City of Surrey
PLANNING & DEVELOPMENT REPORT

File: 7910-0099-00

Planning Report Date: November 1, 2010

- **Rezoning** from RA to RF
in order to allow subdivision into 7 single family lots.

Proposed Subdivision
 High Quality Homes Ltd.
 14472 - 76 Avenue
 Surrey File No. 7910-0099-00

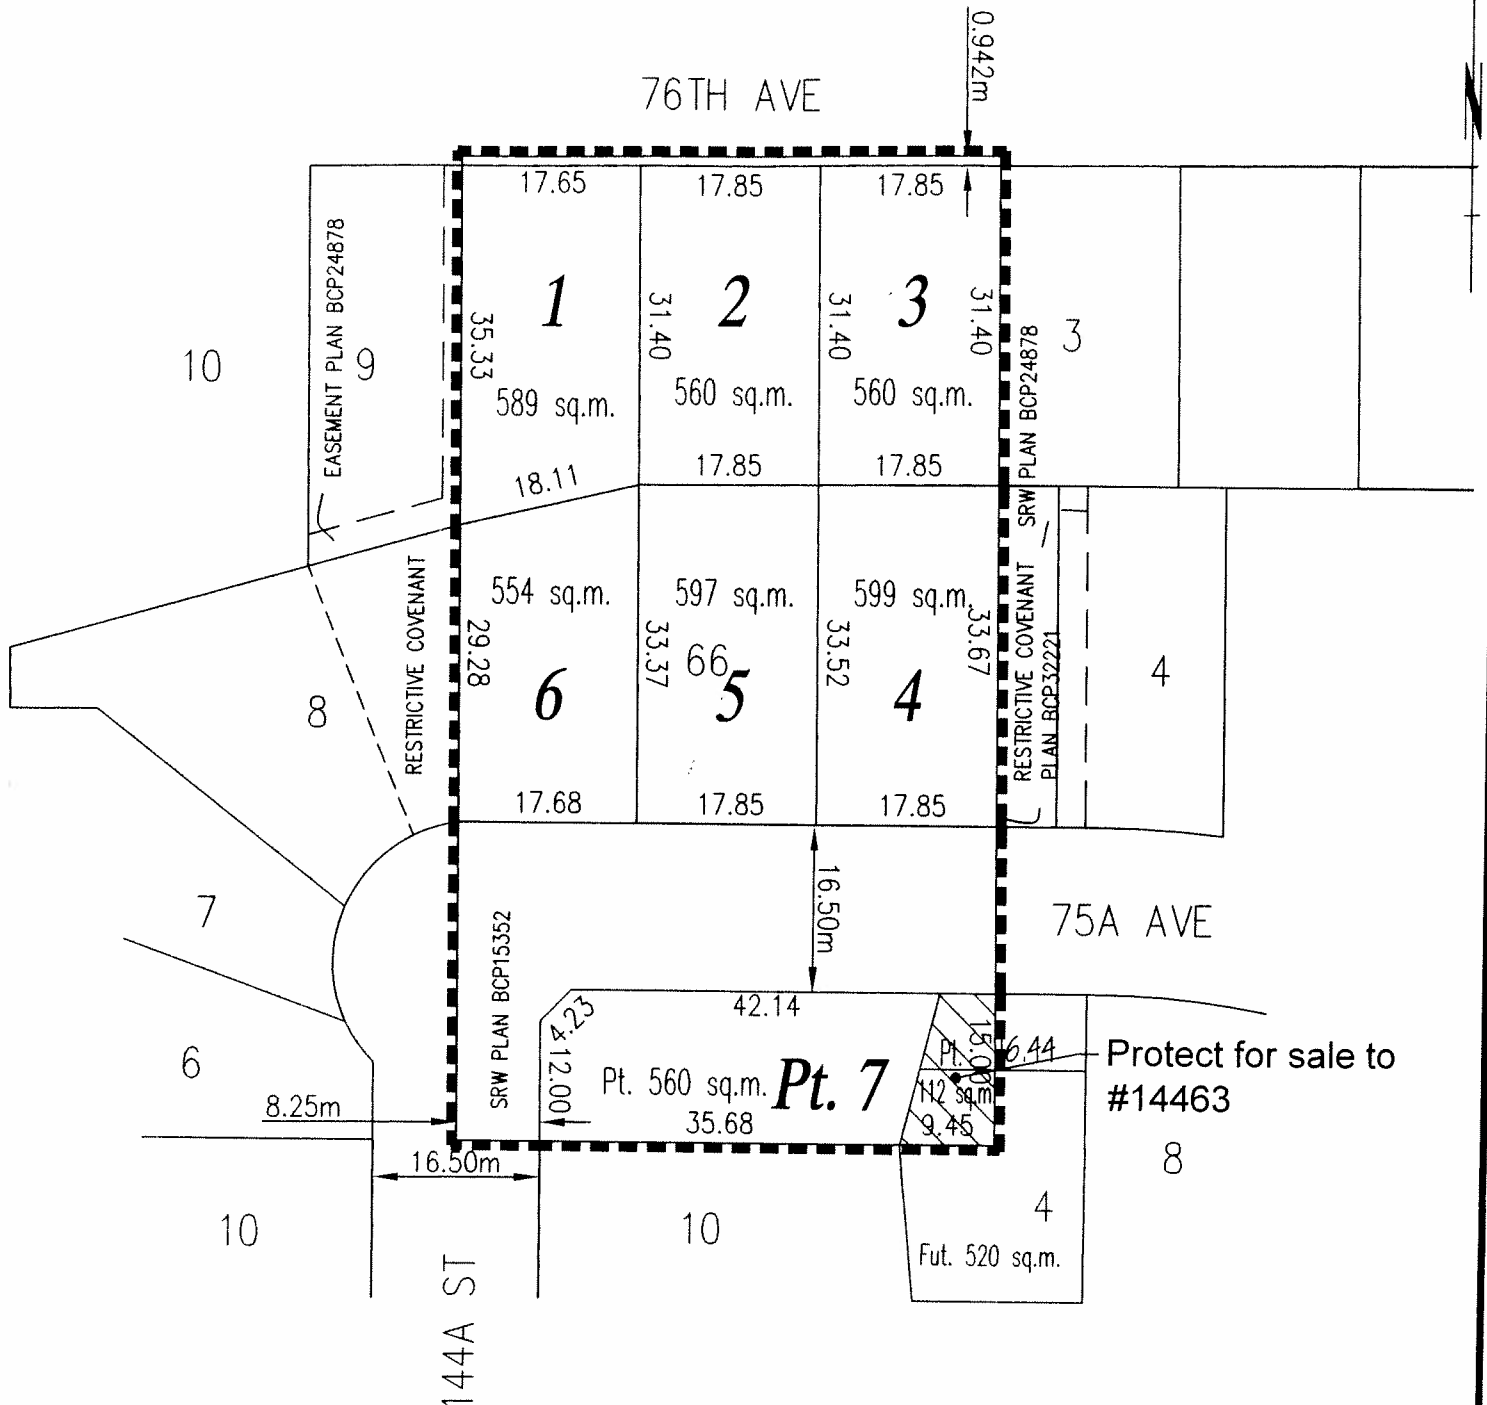
- The lands east and west of the subject property are developed RF subdivisions. All 7 proposed lots conform to the minimum requirements of the RF Zone in terms of lot area, width and depth, except for proposed lot six (6), which requires approval from the Approving Officer at the Subdivision stage of a minor 1.07% reduction in lot area.

- The proposed lots range in size from 554 square metres (5,963 square feet) to 599 square metres (6,448 square feet). The proposed lots range in width from 15 metres (49.2 feet) to 18.1 metres (59.4 feet). The proposed lot areas and widths are consistent with the existing lots in the area.

Proposed Subdivision
High Quality Homes Ltd.
 14472 - 76 Avenue
 Surrey File No. 7910-0099-00

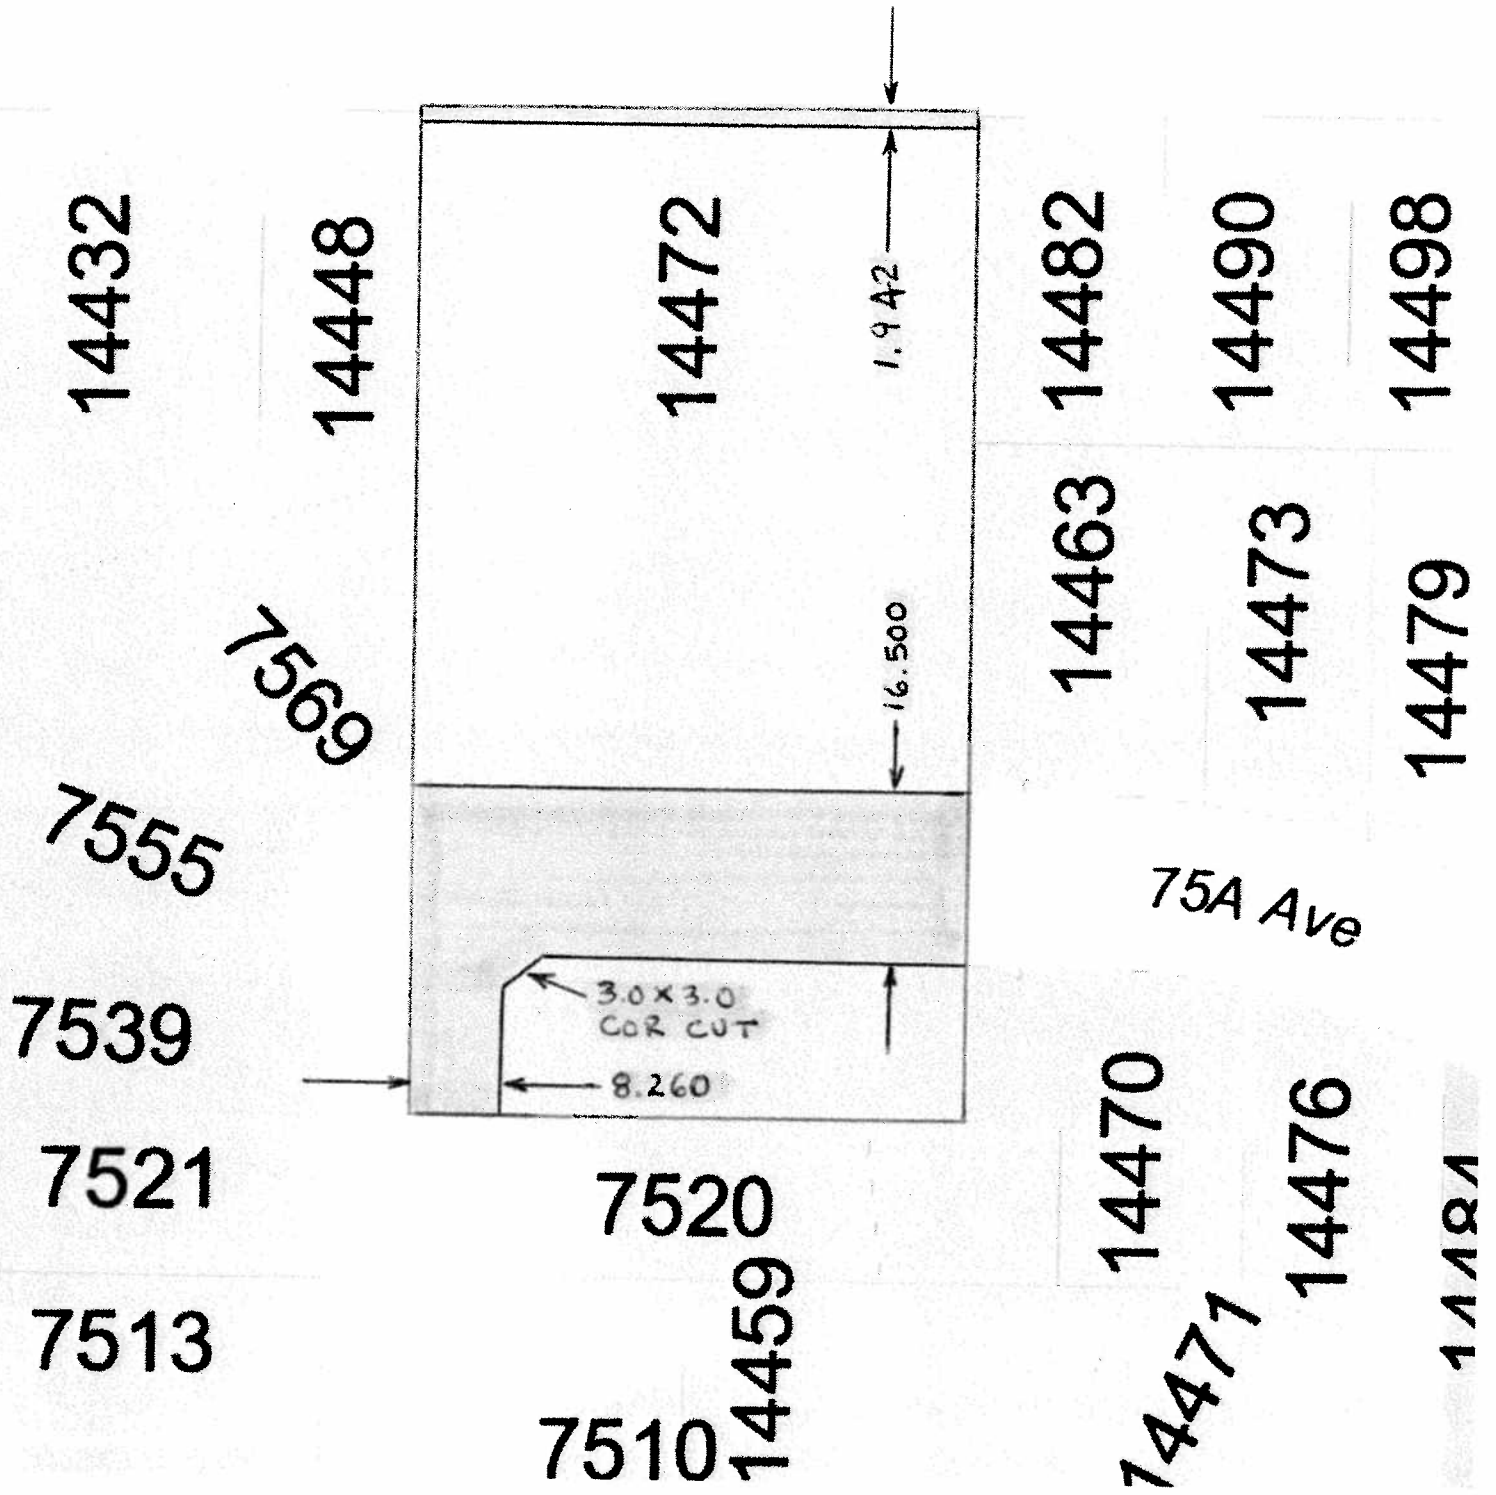
The following road right-of-way dedication, as illustrated on the Road Right-of-Way Requirements sketch attached, is required on existing roads fronting the site:

- 0.942 metres on 76 Avenue;
- 16.500 metres for 75A Avenue;
- 8.260 metres on 144A Street; and
- 3.0m x 3.0m corner cut at the intersection of 144A Street and 75A Avenue.
